MWO 9-2320-272-20-6

FUEL TANK VENTILATION KIT
MODIFICATION WORK ORDER

MODIFICATION OF 5-TON
M939 AND M939A1 SERIES TRUCKS

FIGURE 8

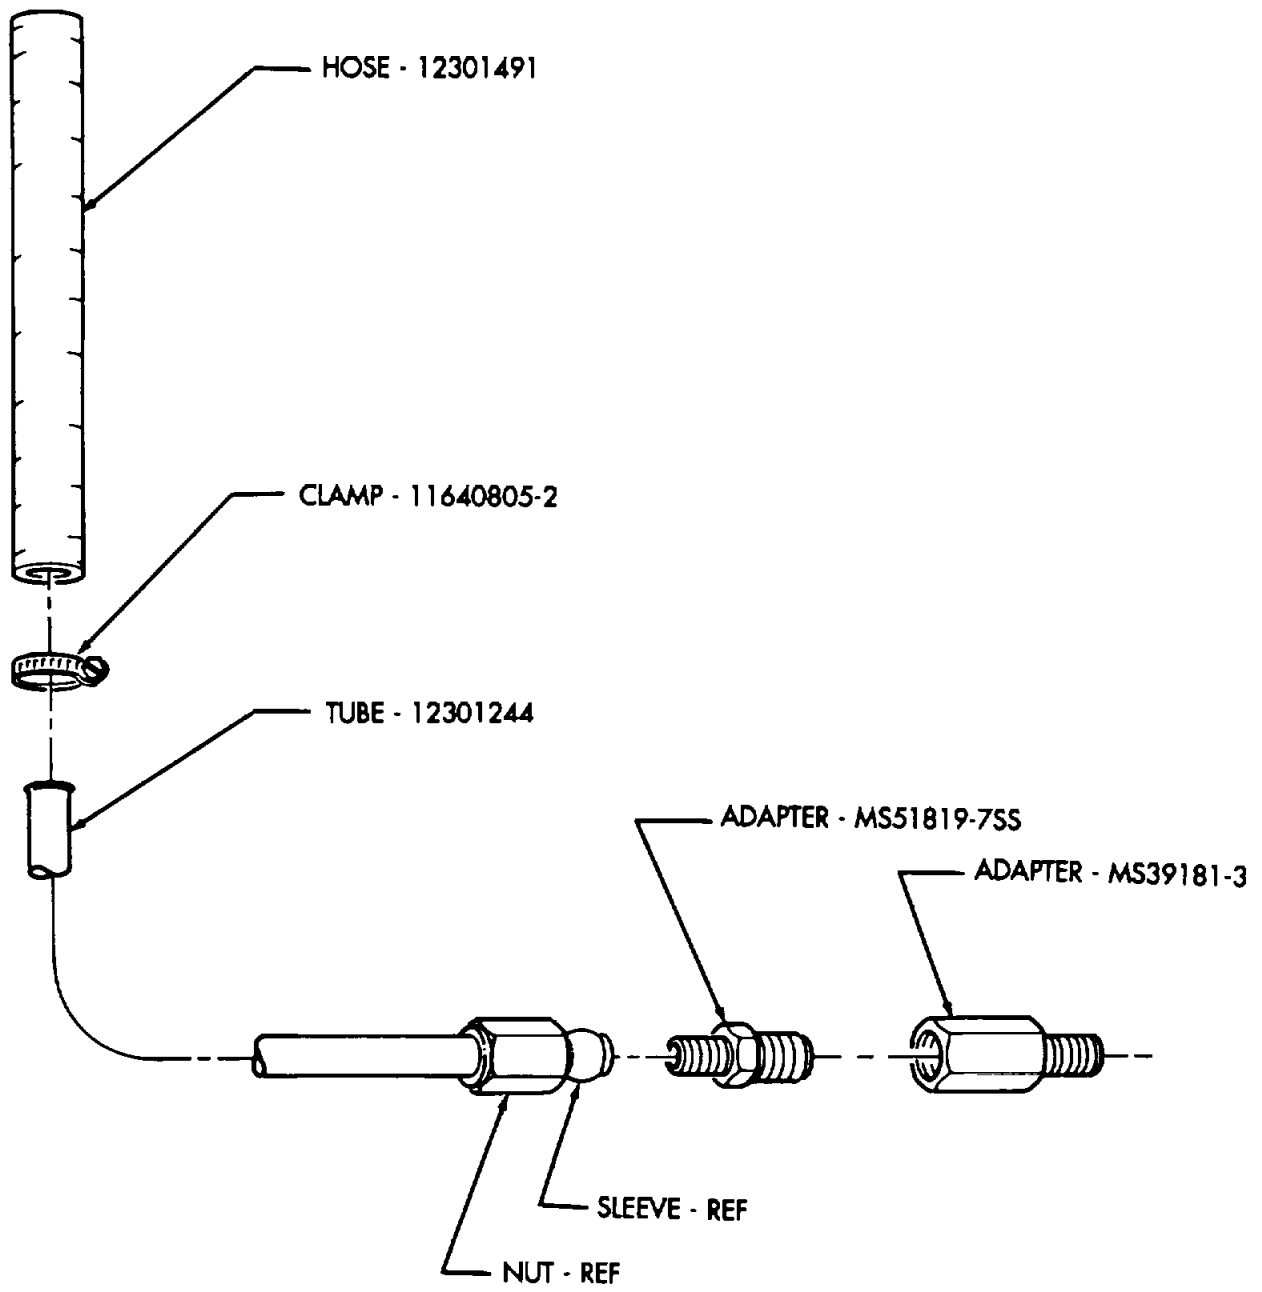
- (9) Install nut, sleeve, and MS51819-7SS adapter on 12301244 tube as shown in figure 8.
- (10) Install tube and adapter on MS39181-3 adapter as shown in figure 8. Retain sleeve and nut for use in step 12.

- (11) Install 12301491 hose on tube with 11640805-2 clamp as shown in figure 8.
- (12) Install two nuts and sleeves from adapters removed in steps 8 and 10 on CPR104420-2 tubing as shown in figure 9.

FIGURE 9

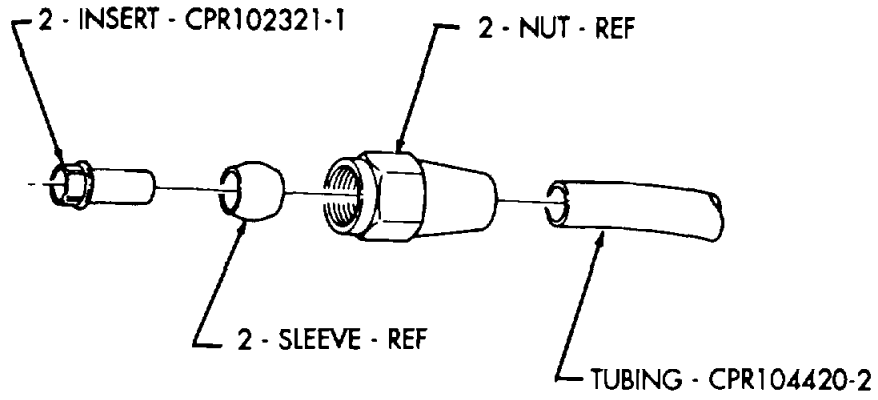
- (13) Install CPR102321-1 inserts in each end of fuel tank vent line as shown in figure 9.

FIGURE 10

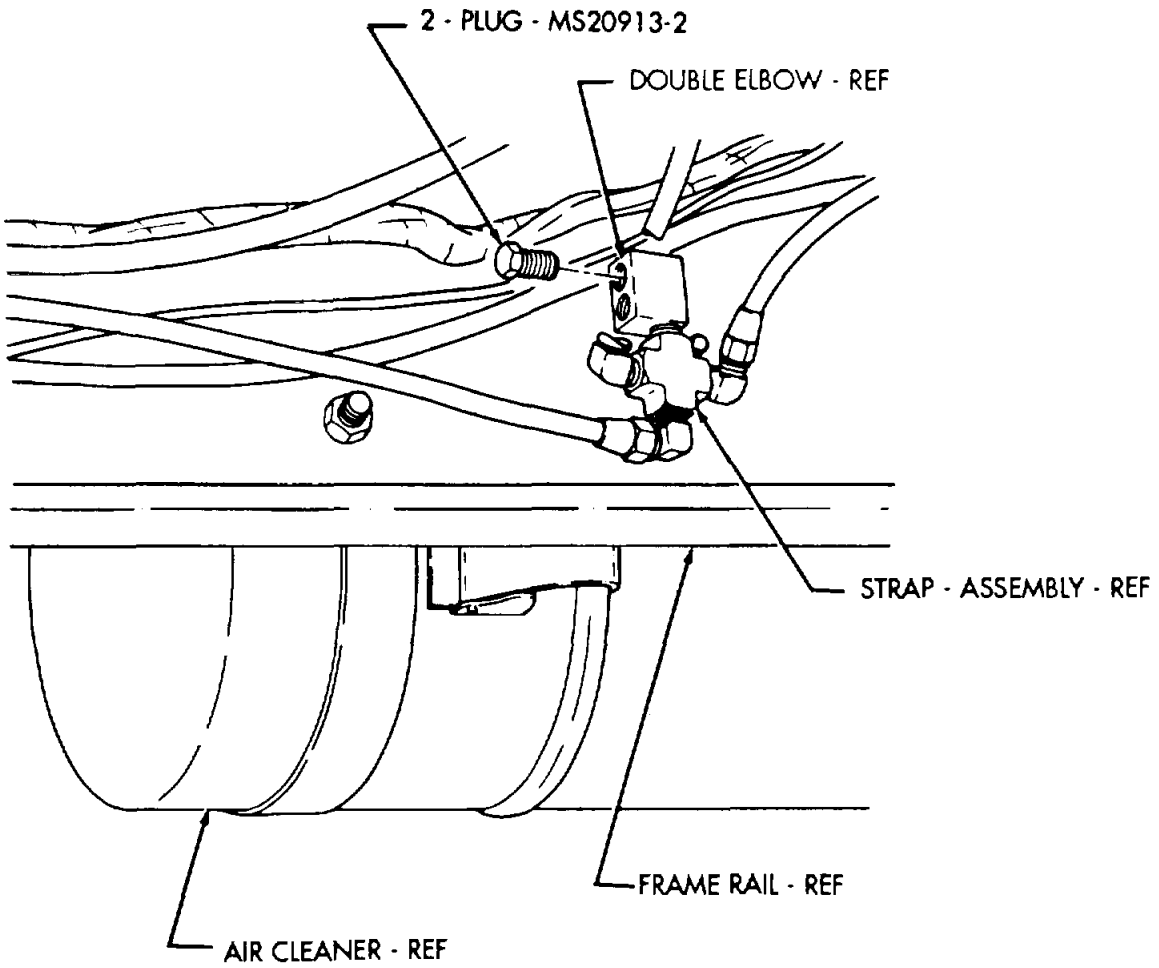
- (1) Install two MS20913-2 plugs in double elbow on strap assembly located inside of frame rail opposite air cleaner as shown in figure 10.
- (2) Install tee assembly on frame rail with MS90726-114 screw and MS51943-40 nut as shown in figures 6 or 7.

FIGURE 11
18

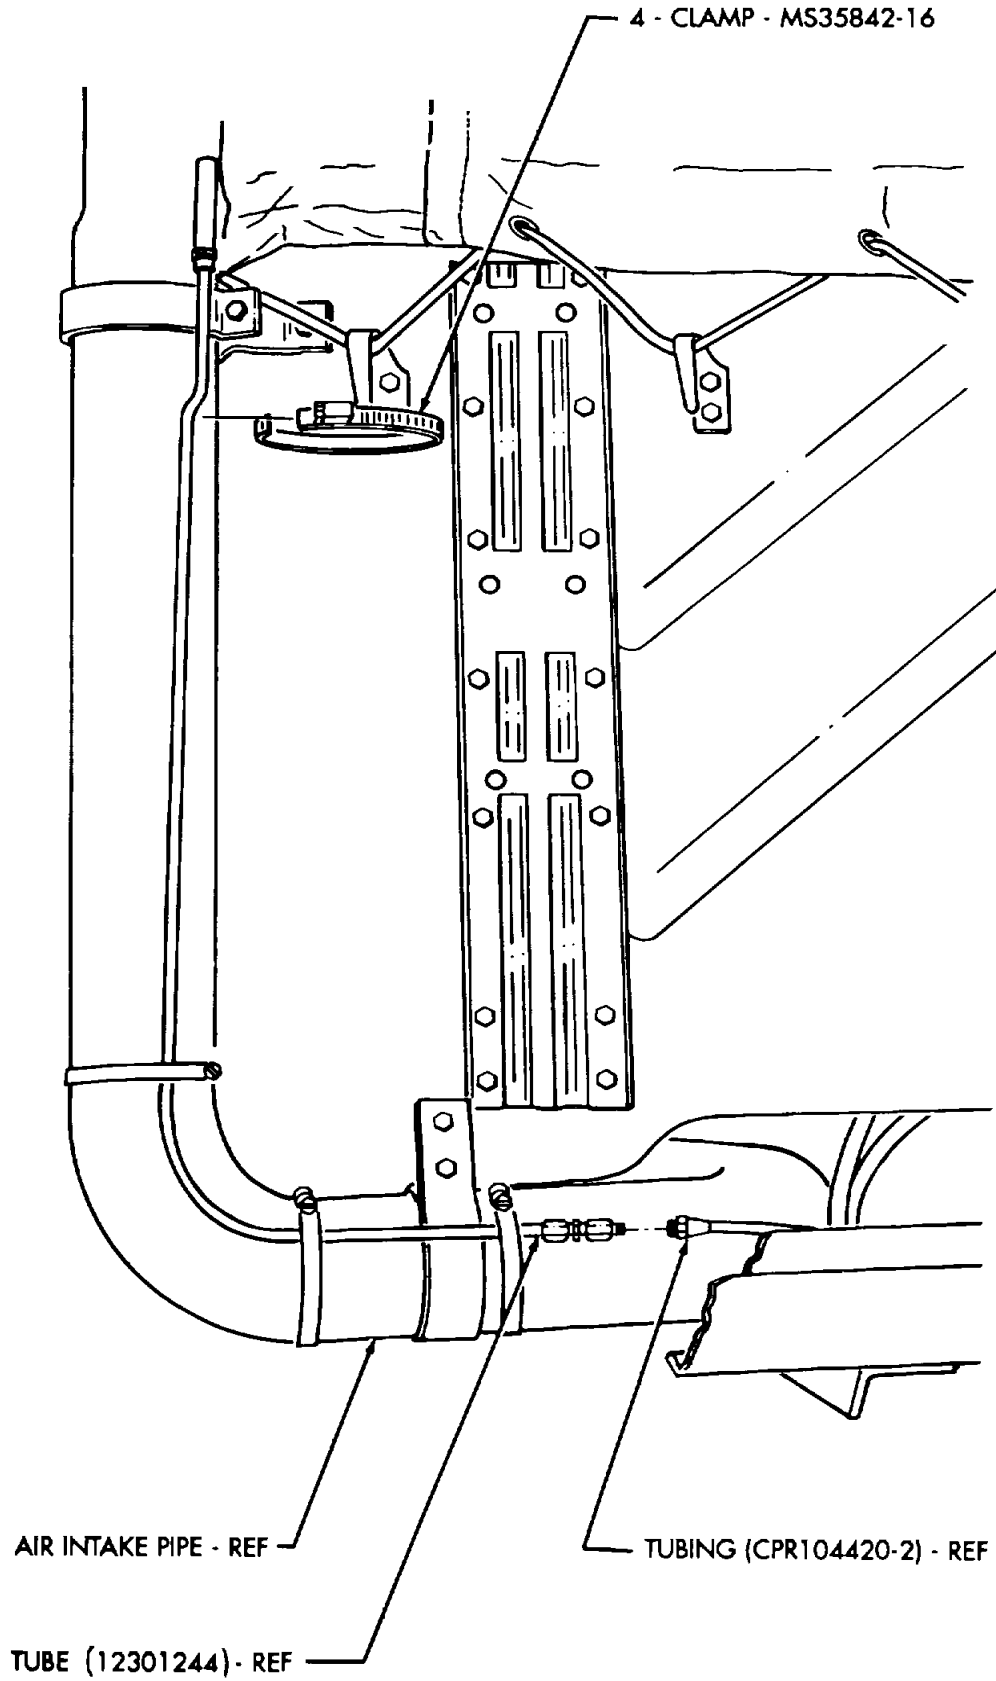
- (3) Connect two fuel tank vent lines from fuel tank-to-tee assembly as shown in figure 6.
- (4) Connect four fuel tank vent lines from fuel tanks-to-tee assembly as shown in figure 7.
- (5) Connect end of CPR104420-2 fuel tank vent line to tee assembly (12301228) as shown in figures 6 or 7.
- (6) Install tube (12301244) on air intake pipe with four MS35842-16 clamps as shown in figure 11. Remove excess clamp ends.
- (7) Connect end of fuel tank vent tubing (CPR104420-2) to tube (12301244) as shown in figure 11.

FIGURE 12

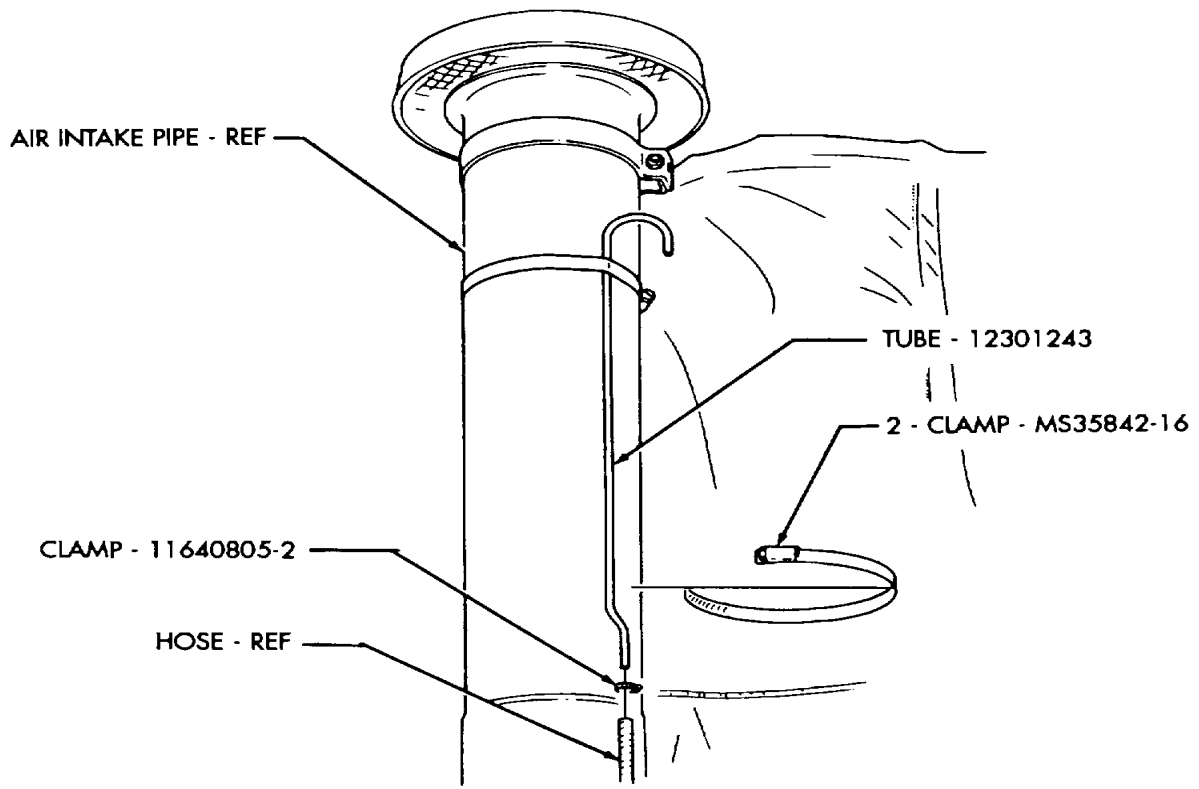
- (8) Install 12301243 tube on hose with 11640805-2 clamp as shown in figure 12.
- (9) Install tube on air intake pipe with two MS35842-16 clamps as shown in figure 12. Remove excess clamp ends.

FIGURE 13

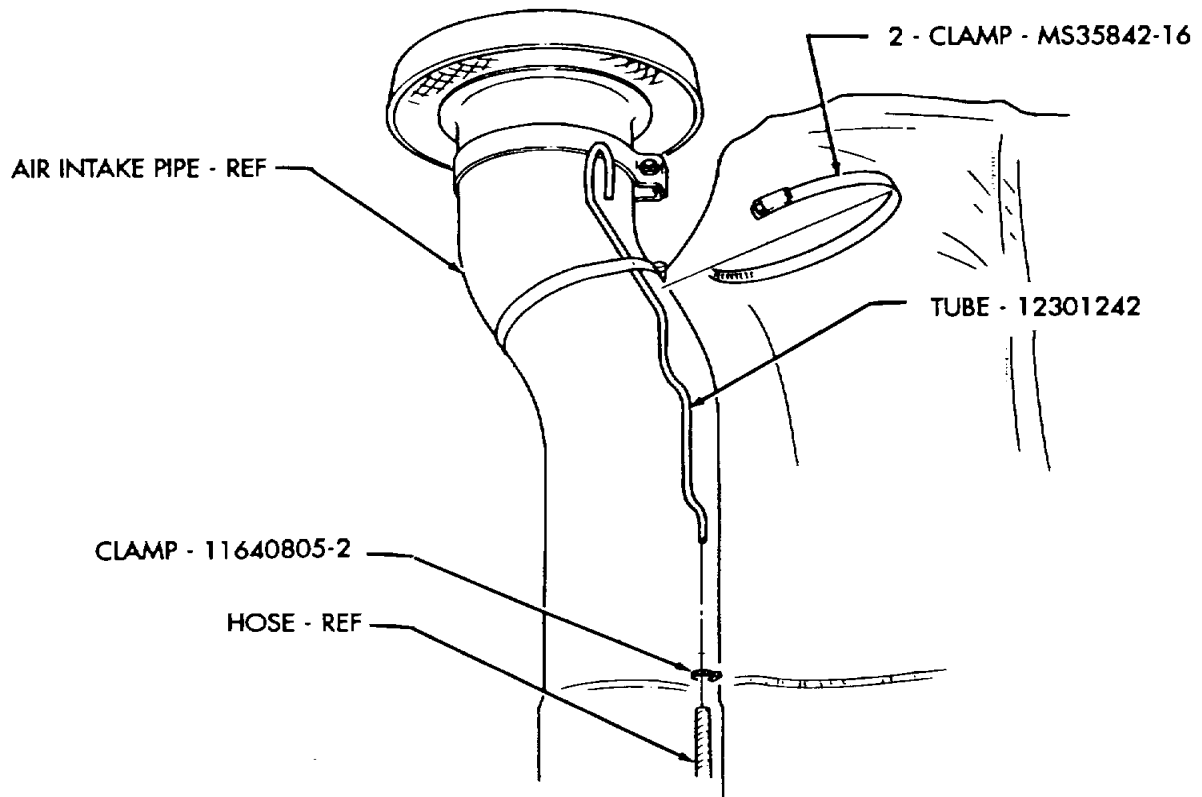
- (10) Install 12301242 tube on hose with 11640805-2 clamp as shown in figure 13.
- (11) Install tube on air intake pipe with two MS35842-16 clamps as shown in figure 13. Remove excess clamp ends.

FIGURE 14

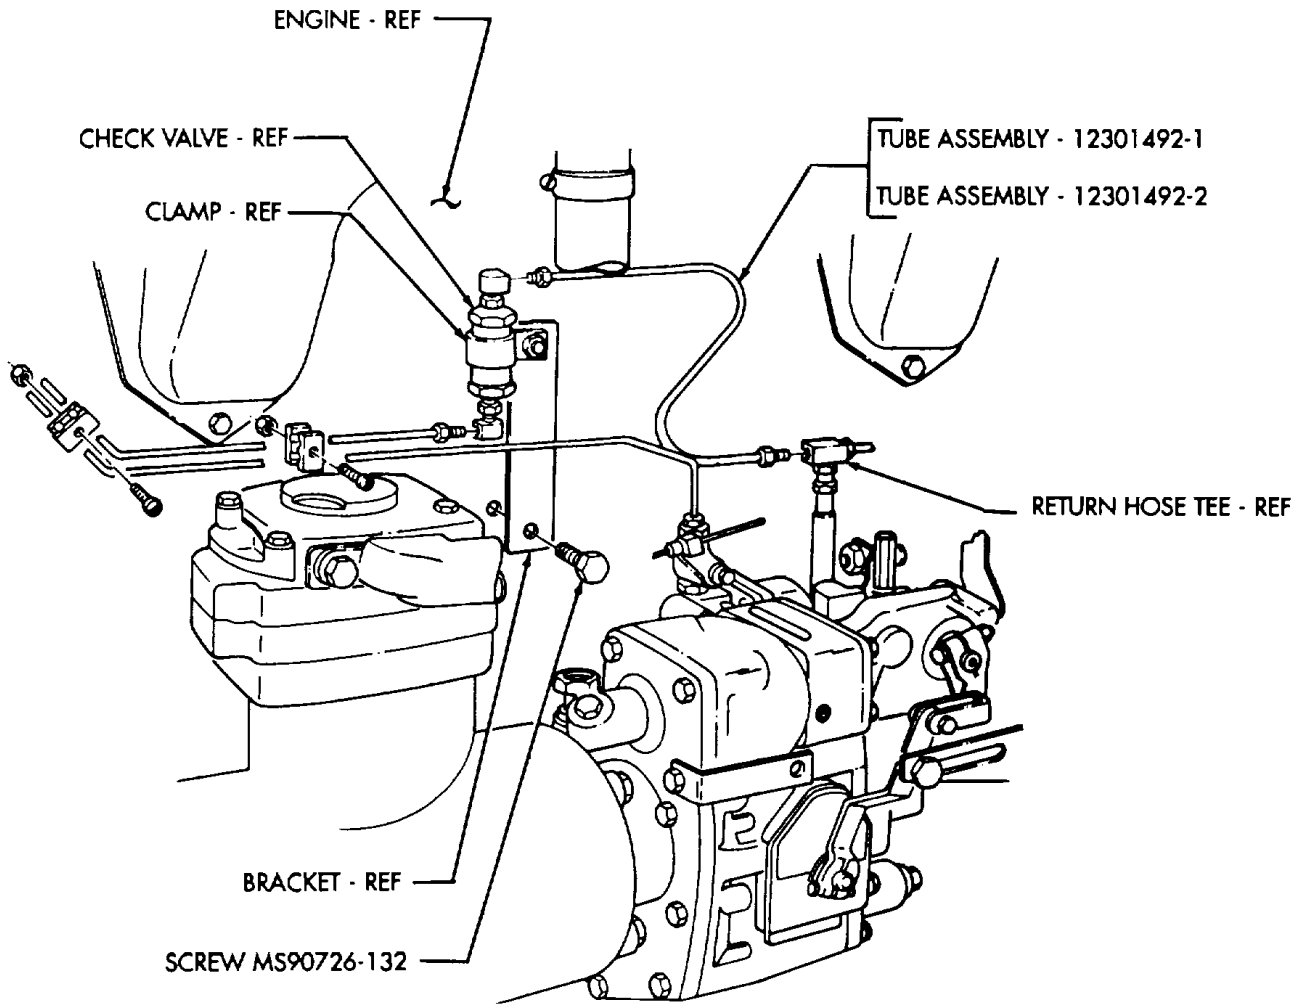
- (1) Install bracket with check valve on engine with MS90726-132 screw as shown in figure 14.

- (2) Connect 12301492-2 tube assembly to check valve and fuel return hose tee as shown in figure 14.
- (3) Connect 12301492-1 tube assembly to check valve and fuel return hose tee as shown in figure 14.
- (4) Connect 12301493 tube assembly to elbow on front of engine and check valve as shown in figure 15.
- (5) Install two clamps on tube assembly and fuel supply line with two screws and nuts as shown in figure 15.

FIGURE 16

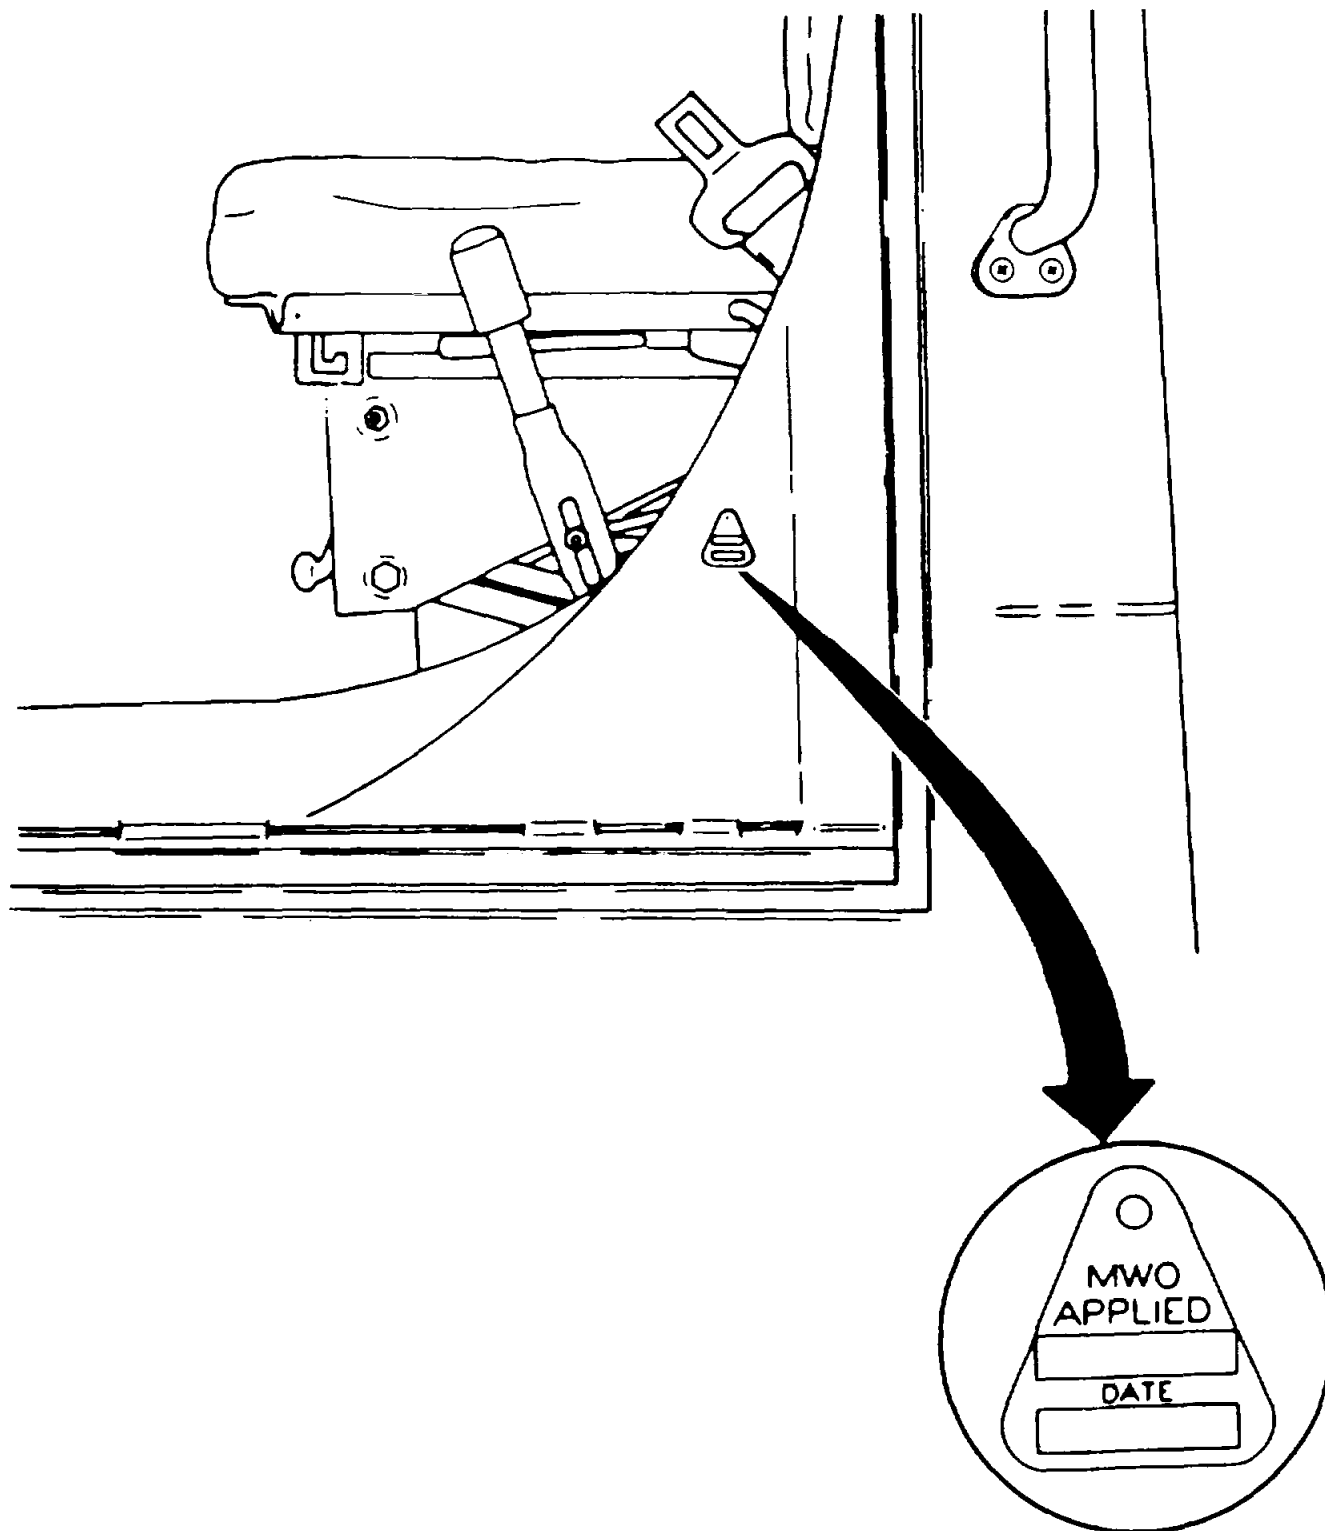
When the Fuel Tank Atmospheric Vent System Kit is installed, it will be identified by the MWO Instruction Plate mounted on the cab body reinforcement panel as shown in figure 16.
